SUMMARY OF VESSEL HEAD AND VESSEL BOTTOM PHONE CALLS

Request for Additional Information Related to Bulletin 2002-01
Arkansas Nuclear One, Unit 1 (ANO-1)

ENTERGY'S DRAFT RESPONSE TO THE NRC'S RAI ON BULLETIN 2002-01

Reactor Vessel Skirt Openings and Locations
Plan View – Looking UP

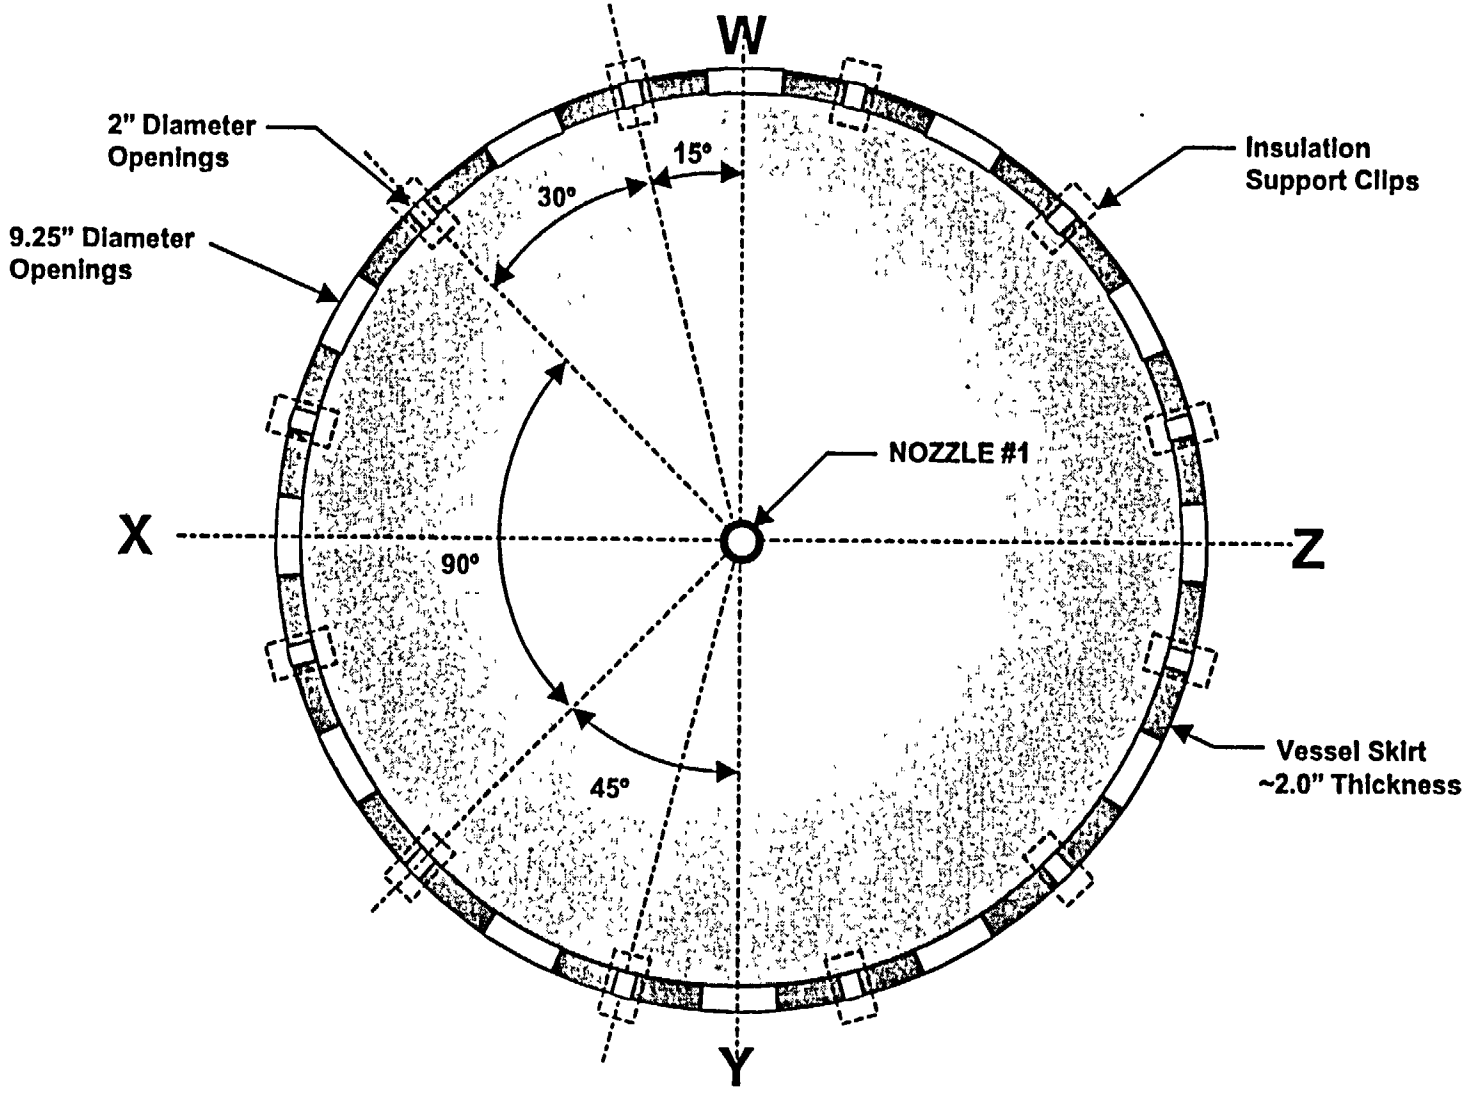
1. Provide detailed drawings and dimensions of the vessel bottom (including the vessel skirt, insulation, etc.) showing the instrumentation nozzles; include on these drawings the boric acid deposits (e.g. staining) based on information obtained from your video tapes. Show the nozzles in the vicinity of nozzle 30 down to nozzle 1 and in the vicinity of nozzle 15 down to nozzle 1.

Attachment 1 (Diagrams of penetrations through vessel skirt, nozzle layout, and description) identifies the nozzles that were inspected using a boroscope and the results. The four nozzles inspected by a boroscope were the only incore tubes that had staining below the insulation. The purpose of the boroscope inspection was to determine whether these nozzles had any evidence of leakage at the vessel interface. Attachment 2 provides a scale composite drawing showing the dimensions of the reactor vessel, support skirt, insulation details, and nozzle 1 and 30.

Postulated Splash Impact and Travel Path Plan View (Looking UP)

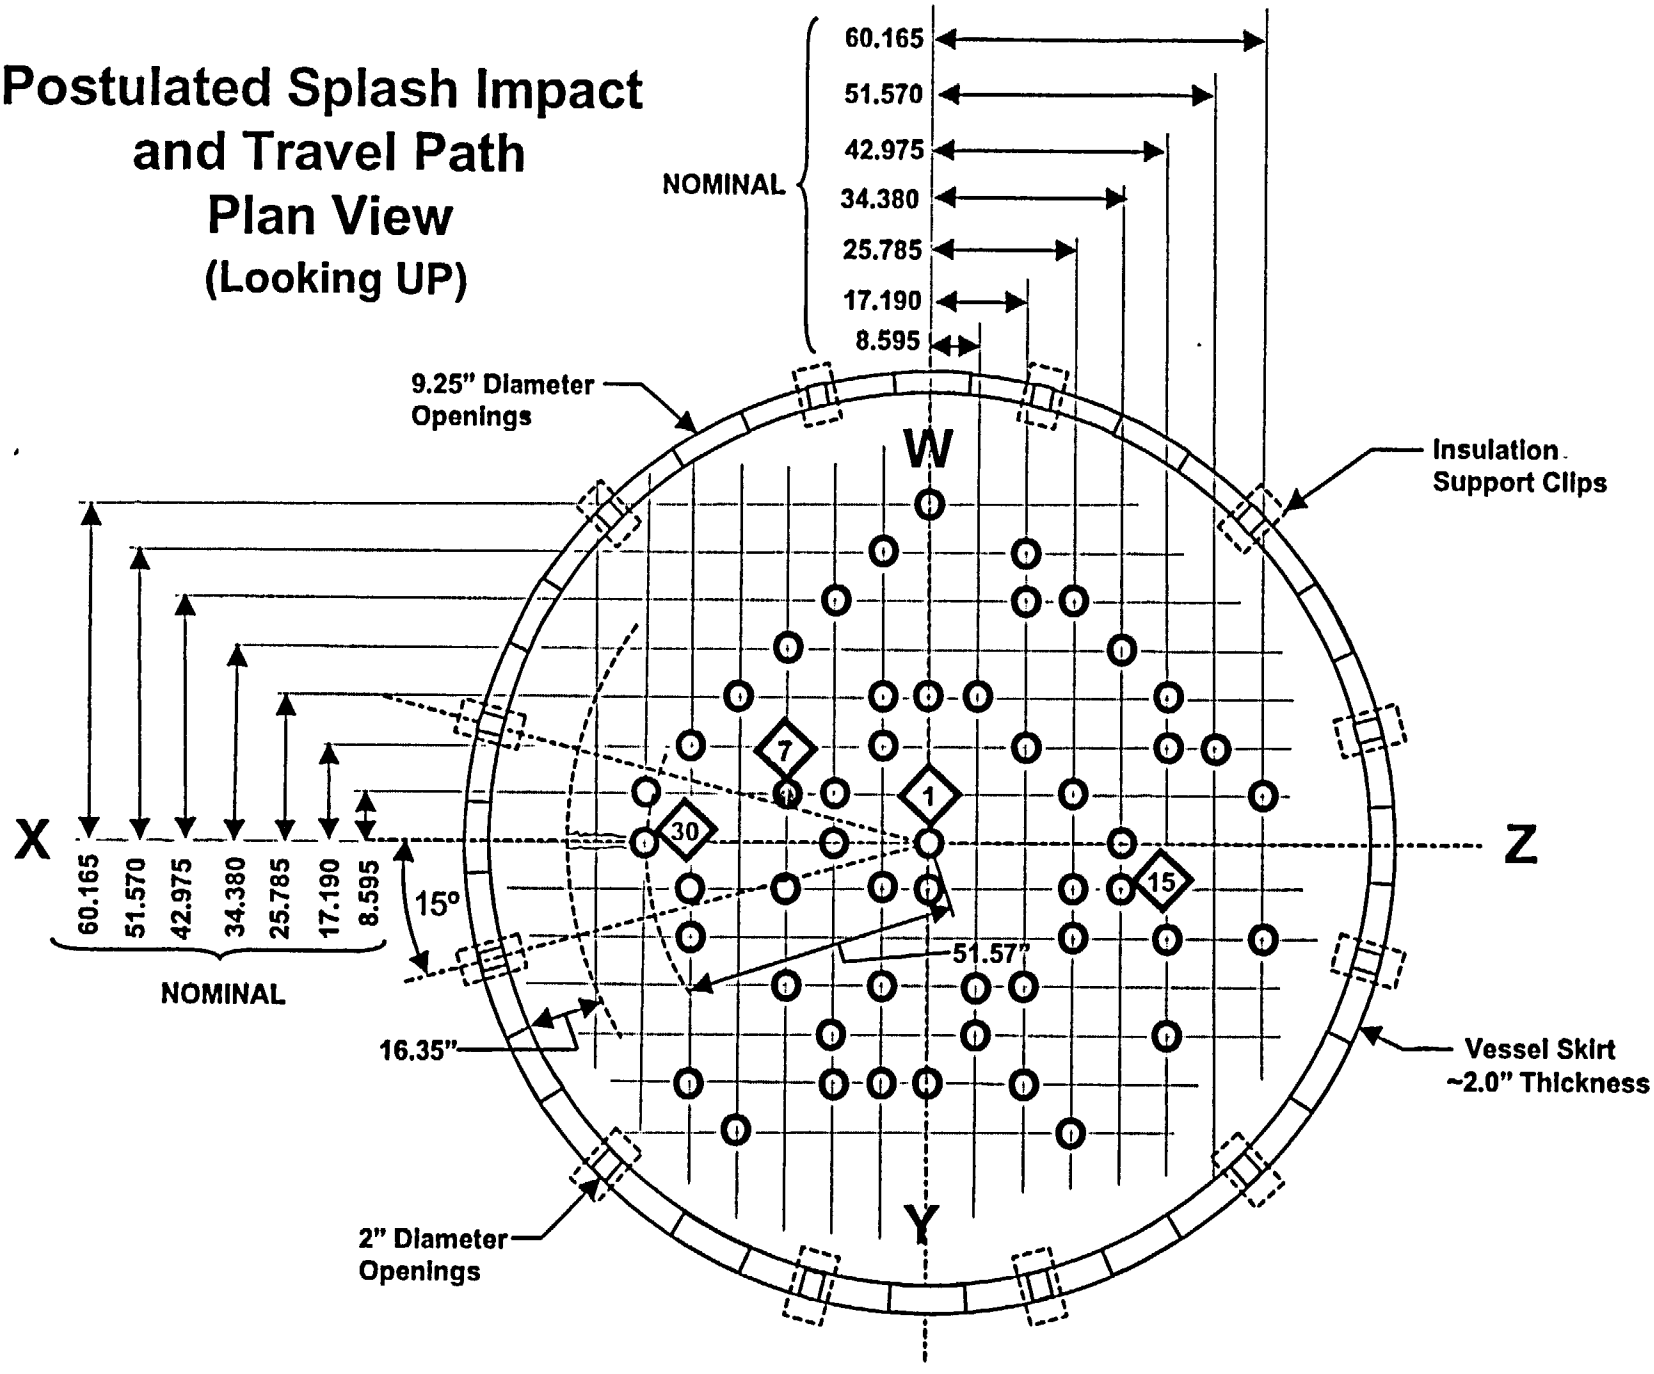
2. Explain your best efforts to locate the source of the boric acid deposits. Address the feasibility of performing additional inspections of the annulus between the vessel/support skirt and the vertical insulation or from the under vessel area to provide further evidence of the path of borated water through the 2 inch support skirt openings.

The reactor cavity seal plate leakage would traverse the annulus area between the vessel and the mirror insulation to reach the undervessel area. The ability to perform additional inspections of the vertical annulus area between the vessel and the mirror insulation has been evaluated. To provide direct visual evidence of the path of borated water through the 2 inch holes in the support skirt above the undervessel insulation, access to the annulus would have to be gained. Possible access routes to inspect the area are limited to access from the top of the reactor vessel and access from below the vessel. There are no access locations between the top and bottom of the vessel because of the primary shield wall. The only openings through the shield wall are around the reactor vessel nozzles and these are too tight a fit to permit access. Access from the top of the vessel to the annulus between the shield wall and the reactor vessel is restricted by the reactor shield blocks. They consist of concrete filled, steel lined blocks. The shield blocks are located below the permanent seal ring at the top of the vessel and above the reactor vessel nozzles. These shield blocks provide a radiation shield in the annulus between the top of the reactor vessel and the floor of the refueling canal. There is no access through these blocks without removing them from above. This can only be accomplished by removing portions of the permanent seal plate.

The only other access to the area between the vessel skirt and the vessel insulation is from the bottom of the vessel. Access of this area is difficult to accomplish. One horizontal insulation panel in proximity to nozzle 30 could be removed to gain access to the area below the holes and a boroscope inserted through the area between the two adjacent incore nozzles, up to the accessible two (2) inch diameter holes located
